Contract #: 04-0120F4
 Cty: SF/ALA Rte: 80 PM: 13.2/13.9
 File #: 69.25B

QUALITY ASSURANCE -- NON-CONFORMANCE REPORT

Report No: NCR-000762

Component: West Shaft 3 Skin C and D

Reference Description: Welding without pre-heat procedure

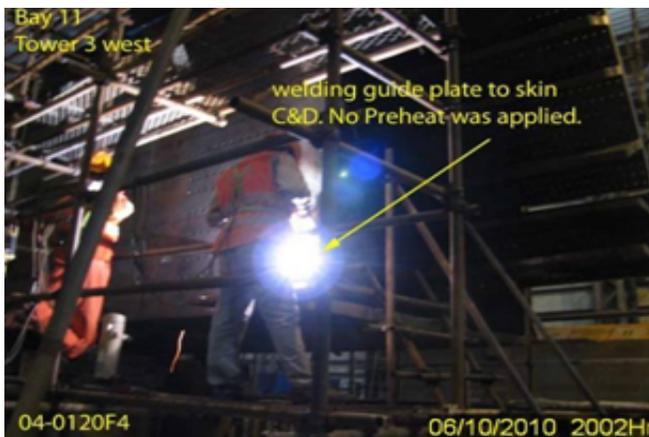
During random in process observations of West Tower Lift 3 Quality Assurance inspector observed the following issues:

- ZPMC welding personnel performing tack welding without preheating.
- Tack welds were placed at the corner intersection of skin plates C & D.
- ZPMC Welding personnel identified as #048647 performed tack welding in the vertical position, which the welder was not qualified in.
- ZPMC has used unidentified material(nuts) for temporary attachments to the skin plates at corner C and D on tower 3 west.
- This QA inspector notified ZPMC CWI identified as Mr. Xu Lefeng and QC inspector identified as Mr. Zhao Mao Mao of this issue. Mr. Man Kan Hon of ABF was also present along with ZPMC QA Zhang Jiauli.

AWS D1.5 section 4 table 4.4;

Minimum Pre heat for material over 60mm is 110 degrees C

AWS D1.5 section 5.22.1 and 5.23.3 table 5.6

A Tack welder shall be qualified by one fillet weld break specimen made in each position in which tack welds are to be made.

ZPMC has removed the unidentified material from the tower and has performed NDT of the material to show that the that base metal is acceptable. ZPMC QA and the production team leader have discussed this non conformance with the welder and reinforced the requirements of welding unidentified attachments onto the tower, to prevent future occurrences. ZPMC requests closure of this NCR.

This proposed resolution is acceptable. The documentation received is sufficient and the Department concurs that Non-Conformance ZPMC-0724 is closed.

Reference Description: Welding without pre-heat procedure

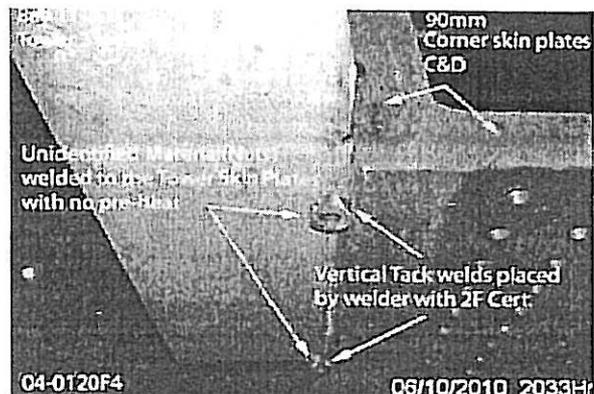
During random in process observations of West Tower Lift 3 Quality Assurance inspector observed the following issues:

- ZPMC welding personnel performing tack welding without preheating.
- Tack welds were placed at the corner intersection of skin plates C & D.
- ZPMC Welding personnel identified as #048647 performed tack welding in the vertical position, which the welder was not qualified in.
- ZPMC has used unidentified material(nuts) for temporary attachments to the skin plates at corner C and D on tower 3 west.
- This QA inspector notified ZPMC CWI identified as Mr. Xu Lefeng and QC inspector identified as Mr. Zhao Mao Mao of this issue. Mr. Man Kan Hon of ABF was also present along with ZPMC QA Zhang Jiaili.

AWS D1.5 section 4 table 4.4:

Minimum Pre heat for material over 60mm is 110 degrees C

Contractor removed the unidentified attachment material, and performed the NDT on the base metal. NDT report showed the base metal is acceptable. ZPMC's QA with the Production Team leader discussed with the welder involved to reinforce the requirements and consequence of welding unidentified attachments on the tower.

探伤位置图

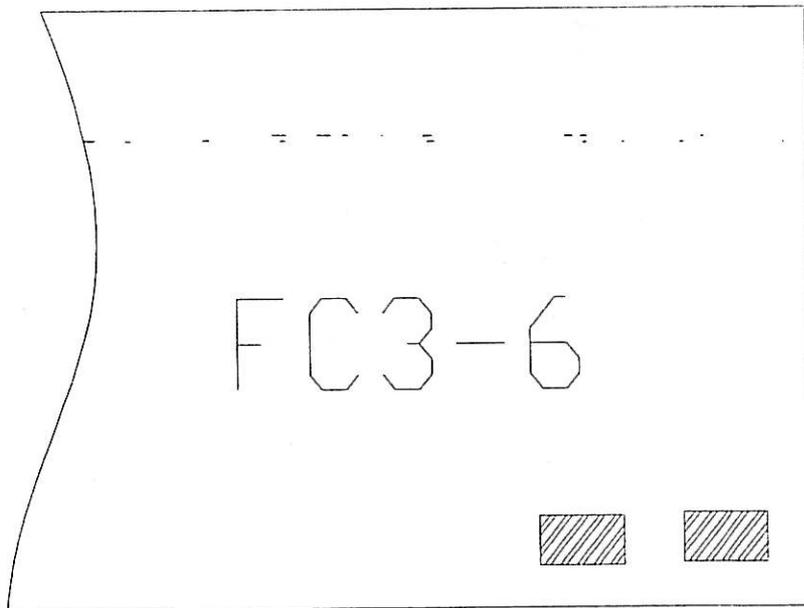
NCR 0724

ZPMC acknowledged this problem, and took action to remove the component and then carried out the base metal MT. Finally the result of these relevant area show good. Here attached the related documents to prove the welds are sound. What's more, we'll enhance the education of this welder.
